BID BULLETIN NO. 02

ITB No.: **PB-07-31-2023-03**

Project Name: **Additional Improvement of RAVE Park (Phase III) at RAVE Park, Brgy. Maybunga, Pasig City**

LOAD SCHEDULE

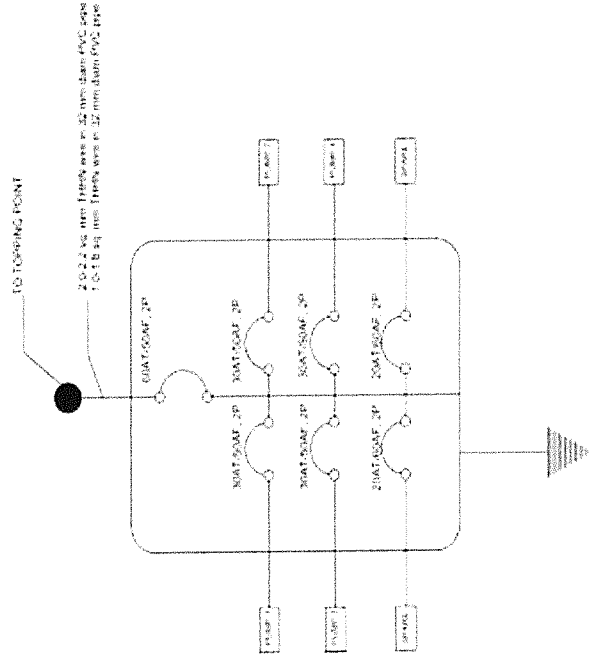
3	<p>ADDITIONAL INFORMATION</p> <p>ITEM NO. 3.0 BOATING LAGOON</p> <p>a.) Rehabilitation of Lagoon</p> <p>MATERIAL SPECIFICATIONS</p> <p>1. PANEL BOARD</p> <ul style="list-style-type: none"> - ENCLOSURE : NEMA 1 POWDERED COATED WITH GROUND TERMINAL - SIZE 6" X 16" X 24" - CIRCUIT BREAKER: GE BOLT ON TYPE 2 POLE, 230 V <p>2. PUMP CONTROLLER:</p> <ul style="list-style-type: none"> - INDIVIDUAL : CIRCUIT BREAKER - : PUSH BUTTON SWITCH ON/OFF - : SIGNAL LIGHT ON/OFF - : CONTACTOR / SWITCH - ENCLOSURE : NEMA 1 POWDER COATED <p>3. PUMPS AND FILTER (4 UNITS)</p> <ul style="list-style-type: none"> - HAYWARD PUMP 3.0 HP - SAND FILTER

CIRCUIT NO.	LOAD DESCRIPTION	NO. OF LOADS	VOLTAGE	AMPERES	CIRCUIT BREAKER		SIZE OF WIRE	SIZE OF CONDUIT	
					AT	AF			
					POLES				
1	PUMP	1	220	2238	30	50	2	2.0-5.5 sq. mm + 1.0-3.5 sq. mm (G)	20 mm dia PVC Conduit
2	PUMP	1	220	2238	30	50	2	2.0-5.5 sq. mm + 1.0-3.5 sq. mm (G)	20 mm dia PVC Conduit
3	PUMP	1	220	2238	30	50	2	2.0-5.5 sq. mm + 1.0-3.5 sq. mm (G)	20 mm dia PVC Conduit
4	PUMP	1	220	2238	30	50	2	2.0-5.5 sq. mm + 1.0-3.5 sq. mm (G)	20 mm dia PVC Conduit
5	SPARE		220	2000	20	50	2	2.0-3.5 sq. mm + 1.0-2.0 sq. mm (G)	15 mm dia PVC Conduit
6	SPARE		220	2000	20	50	2	2.0-3.5 sq. mm + 1.0-2.0 sq. mm (G)	15 mm dia PVC Conduit
TOTAL									
AT 80% DEMAND FACTOR

SIZE OF MAIN WIRE AND CONDUIT:

2.0-2.2 sq mm. THHN in 32 mm diam PVC pipe
 1.0-1.8 sq mm. THHN in 32 mm diam PVC pipe

COMPUTATIONS:

10961/220V=47.10
 USE: 75A2P220 AS MAIN CB
